**Project #22-063  
Old Ephraim Apartments (Second Submittal)  
Located at approximately 655 East 400 North**

**REPORT SUMMARY...**

<i>Project Name:</i>	Old Ephraim Apartments
<i>Proponent / Owner:</i>	Nathan Whittaker / GBN Enterprises LLC & KSF Prop. LLC
<i>Project Address:</i>	655 E. 400 N.
<i>Request:</i>	Design Review Permit
<i>Current Zoning:</i>	Campus Residential (CR)
<i>Type of Action:</i>	Quasi-Judicial
<i>Hearing Date:</i>	February 9 <sup>th</sup> 2023
<i>Submitted By:</i>	Russ Holley, Senior Planner

Figure 2 shows the proposed site plan

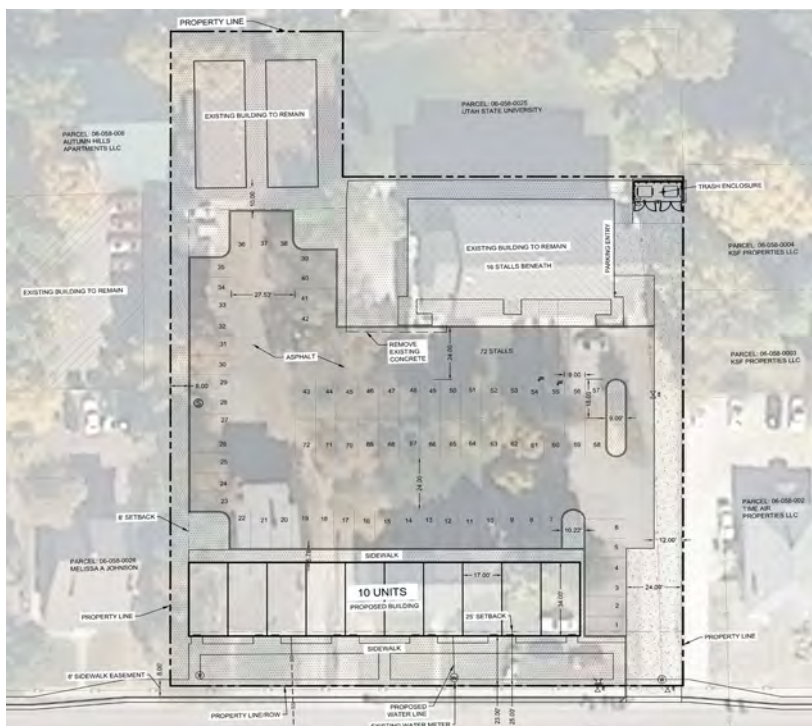
As proposed, the project does not meet the front building setback of 25 feet. The Planning Commission could, at their discretion, approved a ten-percentage deviation from the 25-foot standard. As conditions with front yard compliance, the project meets the setback requirements in the LDC.

3. The front (south) setback shall be 25 feet unless the Planning Commission approves a 23.5-foot setback as per the LDC 17.43.080.
4. The project shall provide 109 parking stalls for all buildings and uses on the 1.29-acre site or have an alternative parking plan approved as per the LDC 17.31. The new building shall provide bike parking as per LDC 17.31.

Figure 1

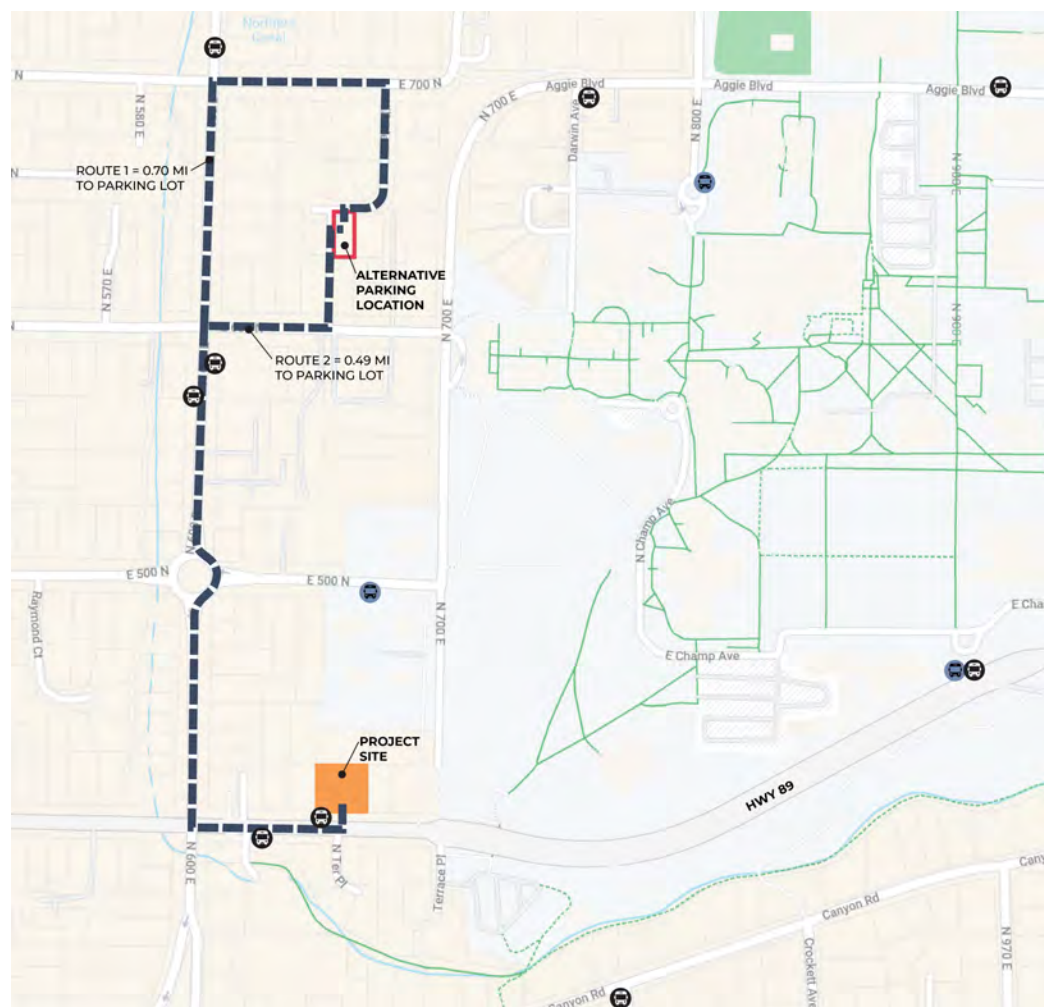
The alternative parking for the project site is to be located at 651 East 600 North. The distance from the project site to the alternative parking location is 0.49 mi entering from 600 N on the south side of the property or 0.70 entering from Hillside Circle on the north of the property. Figure 1, below, shows the quickest routes to the alternative parking location.

Figure 2

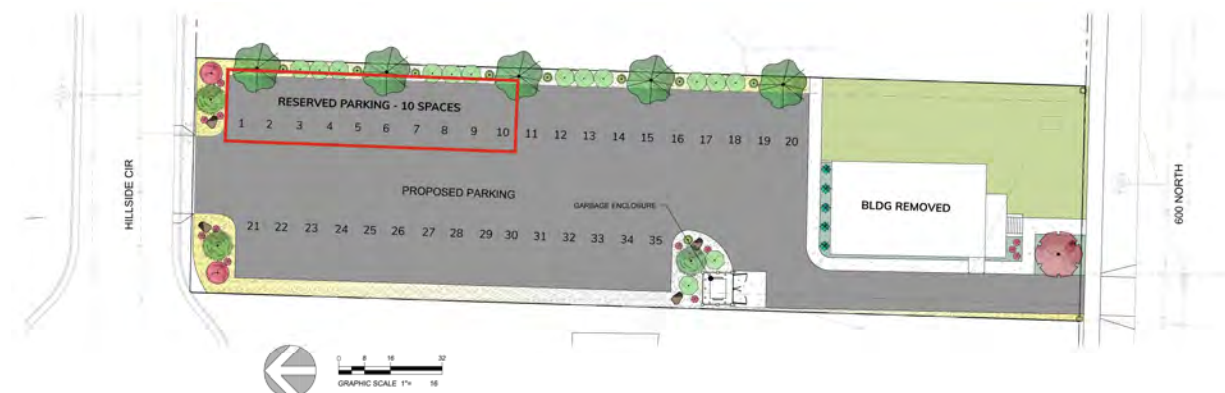
The Hillside parking site will provide 10 stalls continuously reserved on the northeast end of the site shown in figure 2 below. These stalls will be marked and reserved year round for the parking site of the new housing project.

*Figure 3*

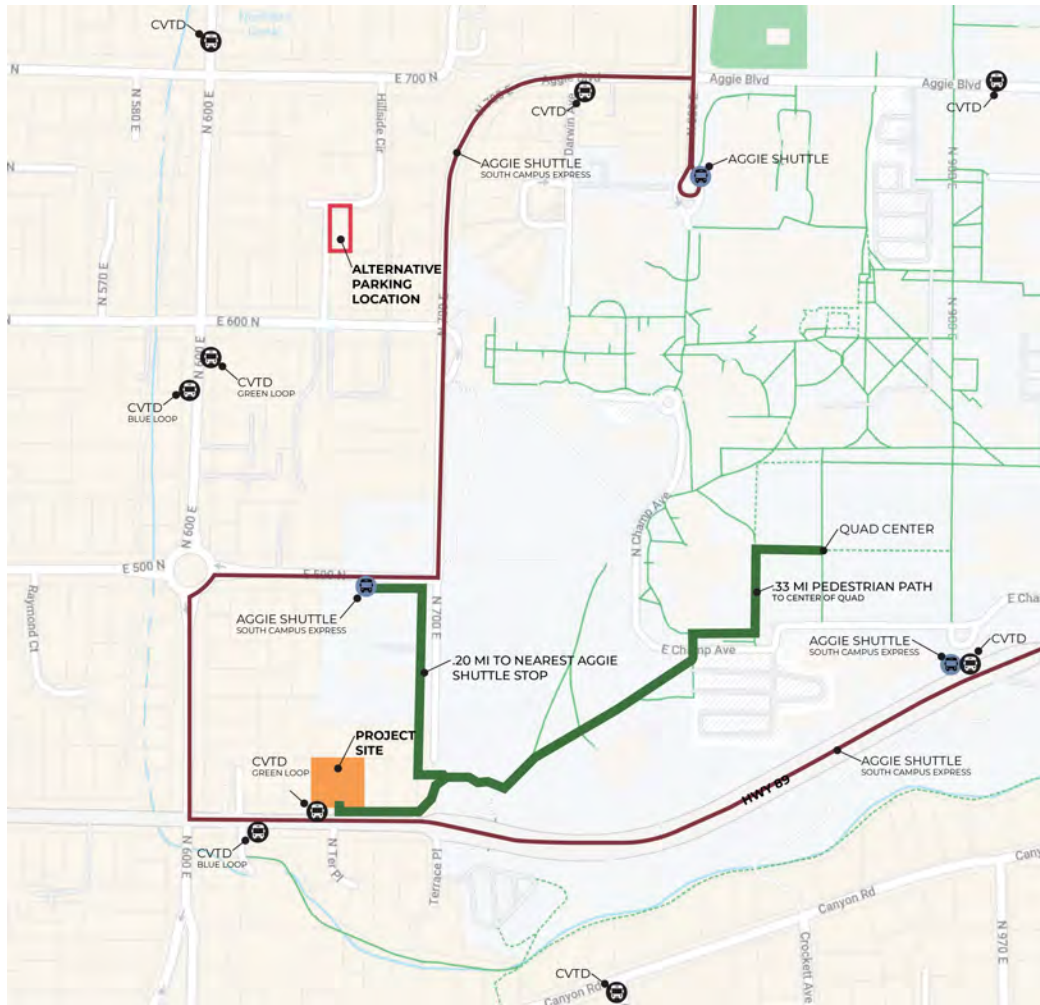
With multiple modes of transportation options in close proximity of the project site and the closeness of the University Campus, this shows the reasoning and feasibility for a reduction in parking. Figure 3 shows the distances to the campus on pedestrian paths, as well as the CVTD and Aggie Shuttle bus stop locations that are in close proximity to the project site.
